Re: Work Plan and QA/QC Plan for Groundwater Investigation at El Dorado Chemical Company, El Dorado, Arkansas.

GEOLOGIC INVESTIGATION AND WELL INSTALLATION WORK PLAN

From: Randall Whitmore [RWhitmore@edc-ark.com]
Sent: Friday, November 07, 2003 12:17 PM
To: 'STUART@adeq.state.ar.us'
Subject: RE: EDCC work plan

**PROPOSED BORING AND
MONITOR WELL LOCATION MAP**

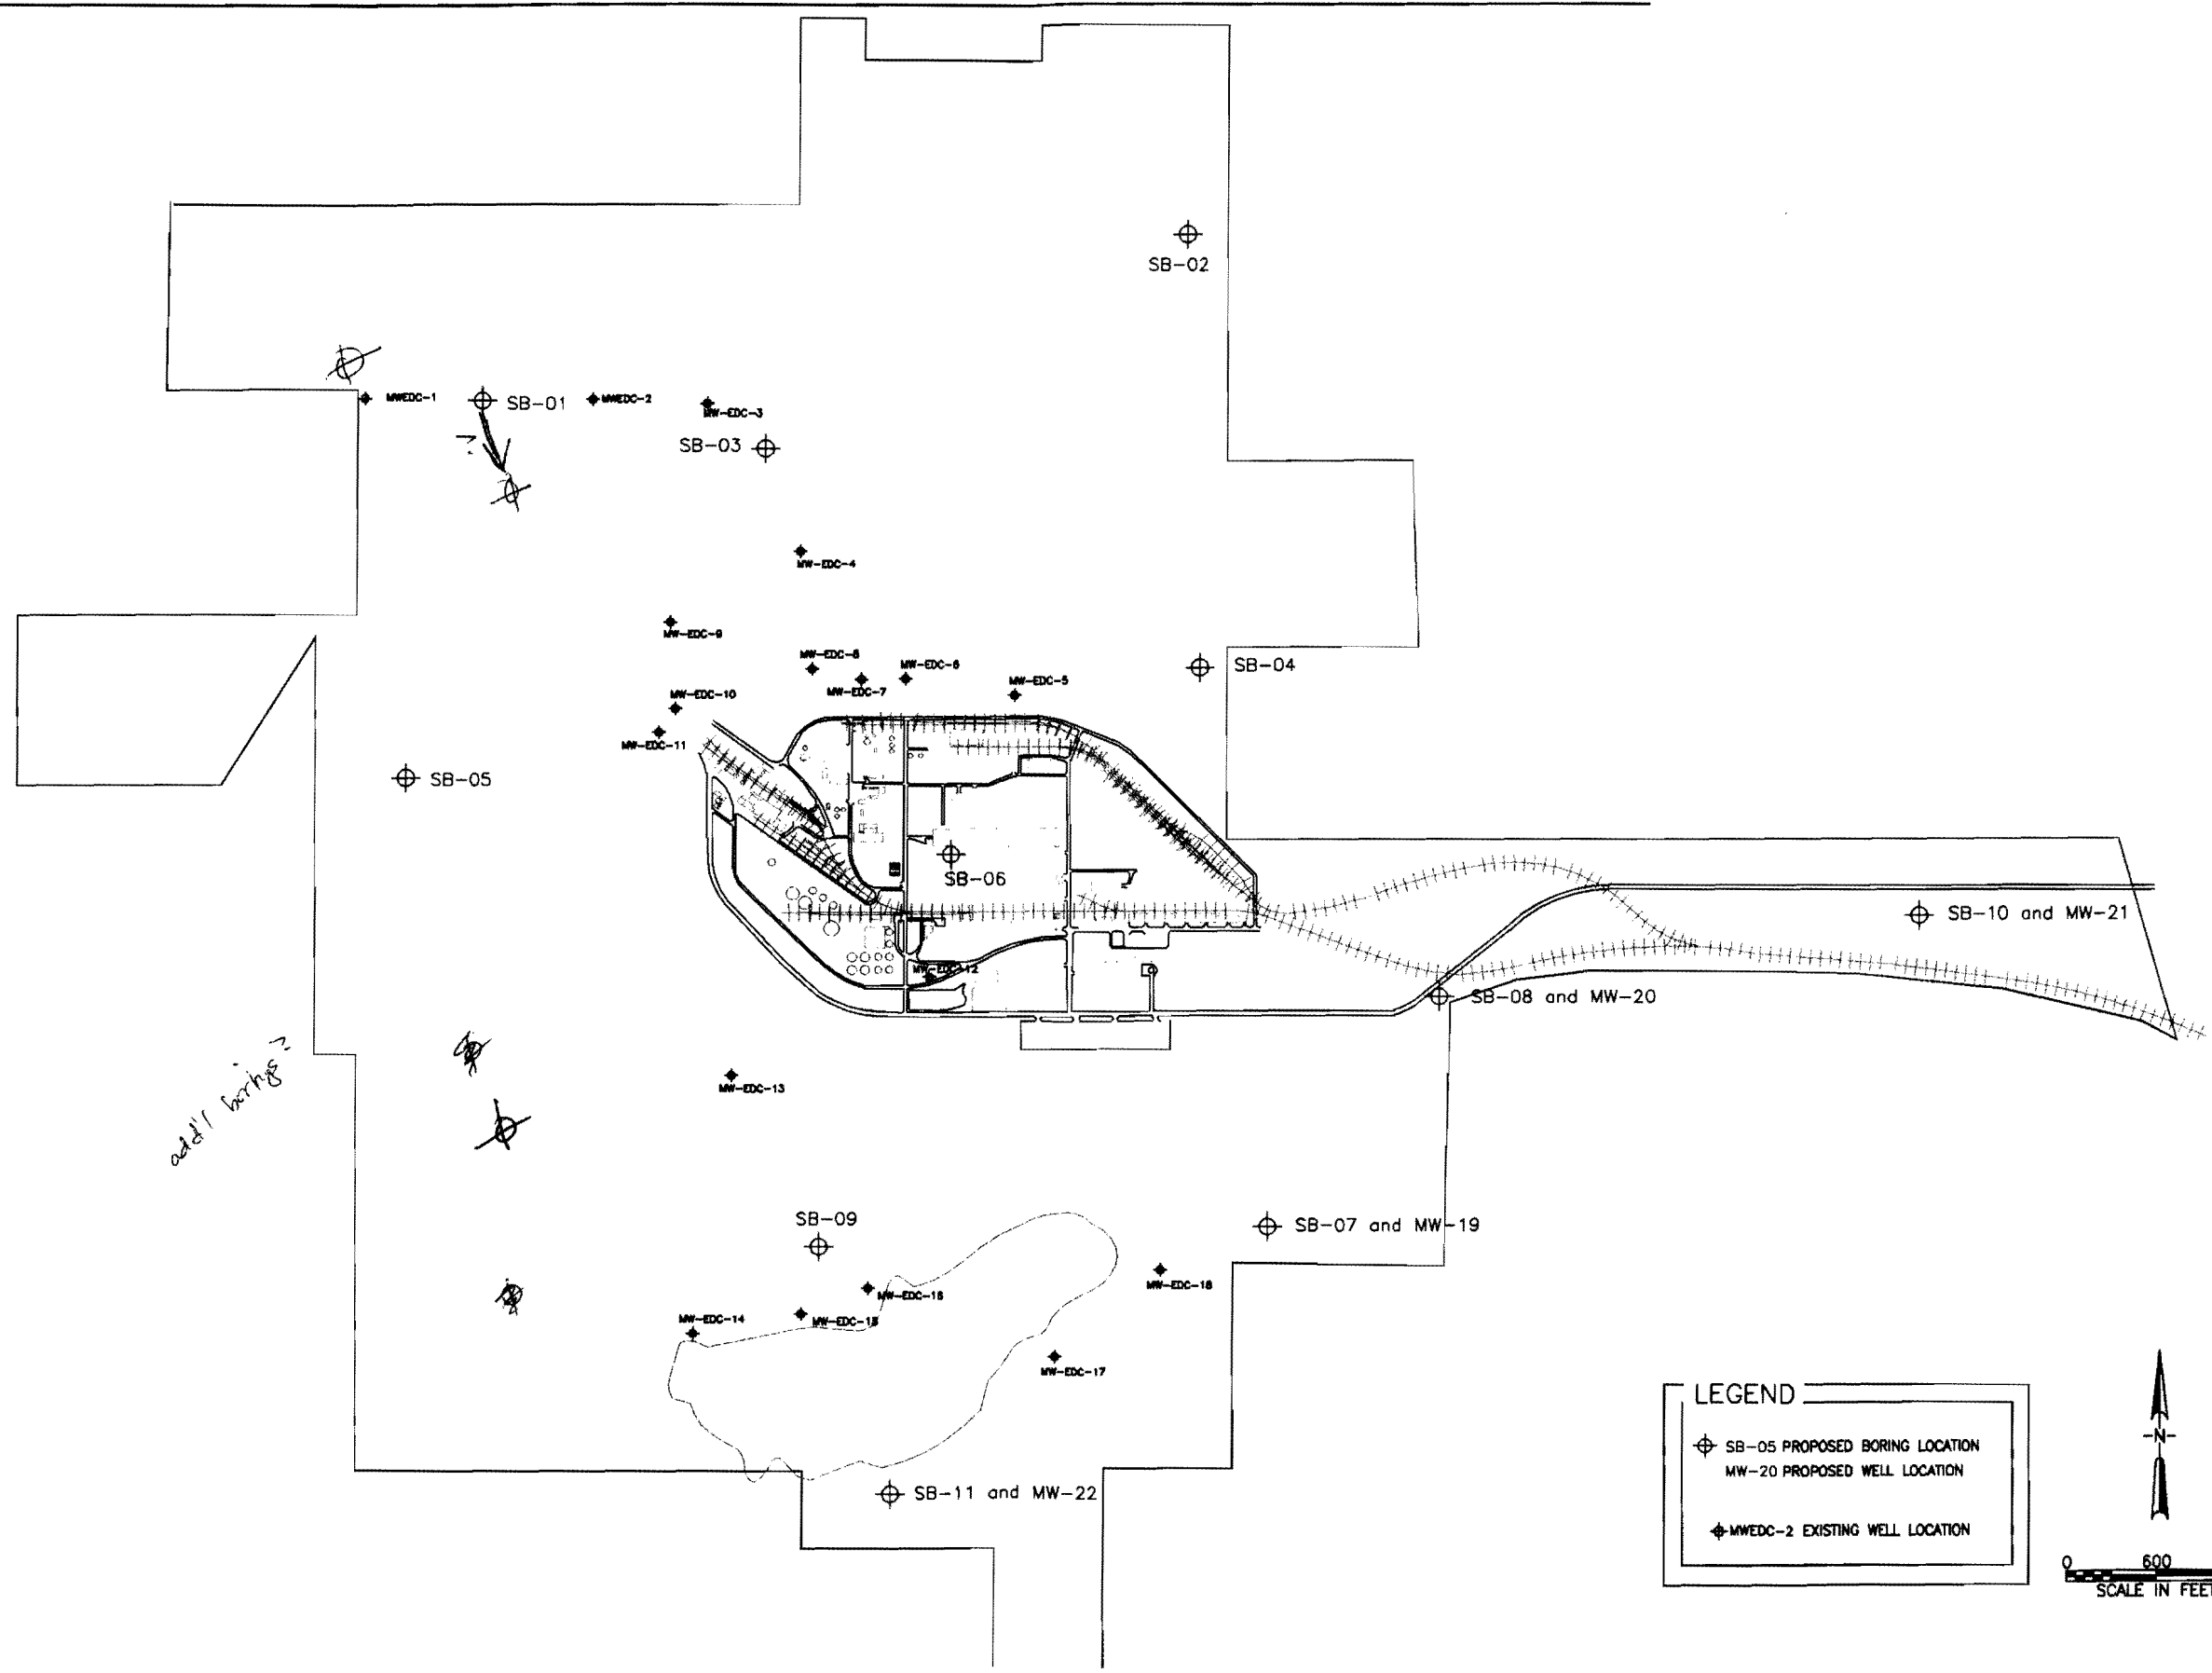
add 11 borings

TYPICAL WELL CONSTRUCTION
DIAGRAM

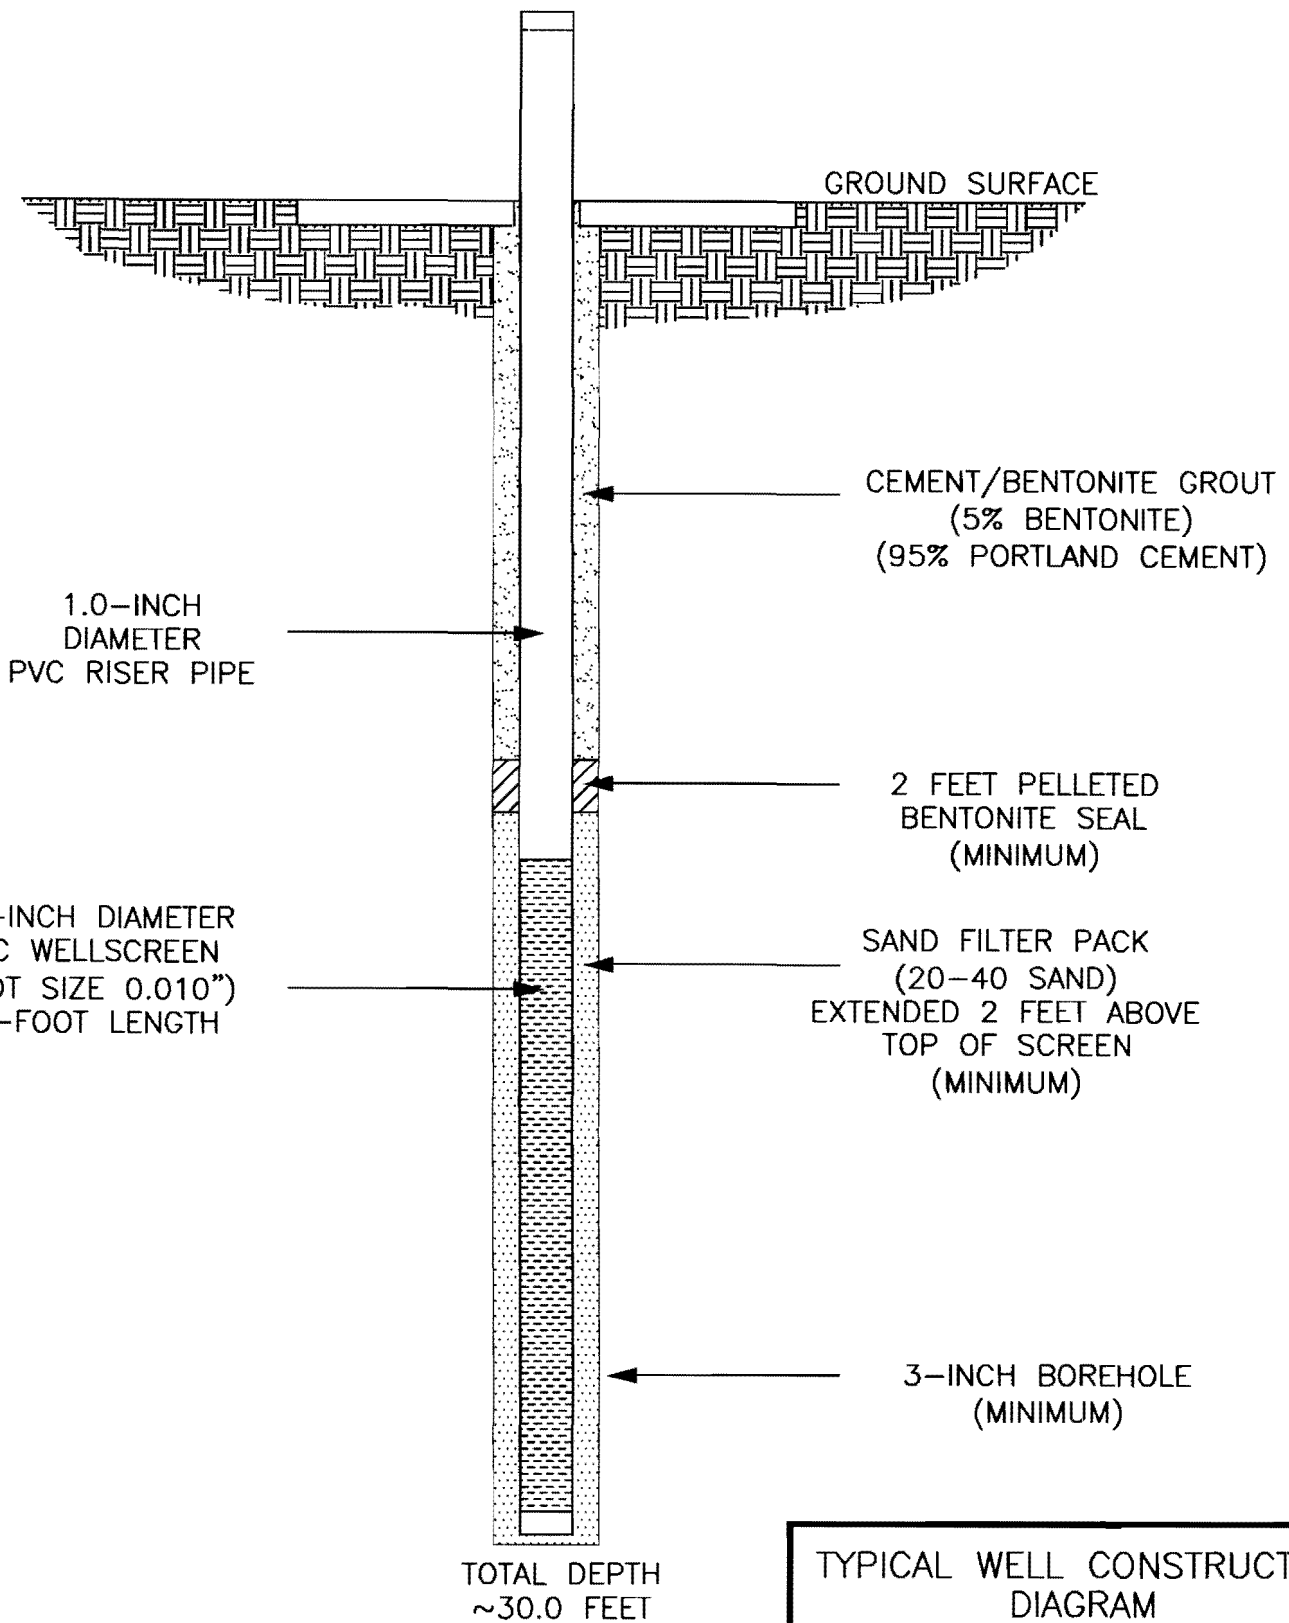
— what length screen in eq. well?

2.125" well casing (pulled up?)

1.5" well → see fig 2 w/ 1" diam.

→ 0.625" filter pack, grout + screen

Clarification between Section 3.2, Pg 4 and Figure 2: Figure 2 shows a 1.0" diameter casing and screen, but in section 3.2, a 2.125" diameter casing is pulled up during filter pack placement. I'm assuming 1.0", but does the filter pack, screen and grout make up the difference between 1.0" pipe and 2.125"?

According to Figure 2, the screen length will be 10'. Depending on boring/well logs, it may be necessary to extend the screen length. I would rather see the screen length based on site conditions. However, since all the other wells have 10' screens, it might be best to maintain consistency. What are your thoughts?

Clarification between Section 3.2, Pg 4 and Figure 2: Figure 2 shows a 1.0" diameter casing and screen, but in section 3.2, a 2.125" diameter casing is pulled up during filter pack placement. I'm assuming 1.0", but does the filter pack, screen and grout make up the difference between 1.0" pipe and 2.125"? [Randall Whitmore] The 2.125" casing is the drilling casing. The well will be set inside this casing. The finished well will be 1" diameter.

According to Figure 2, the screen length will be 10'. Depending on boring/well logs, it may be necessary to extend the screen length. I would rather see the screen length based on site conditions. However, since all the other wells have 10' screens, it might be best to maintain consistency. What are your thoughts? [Randall Whitmore] We should use at least 10' of screen but we can add additional screen in 2.5', 5' and 10' lengths.
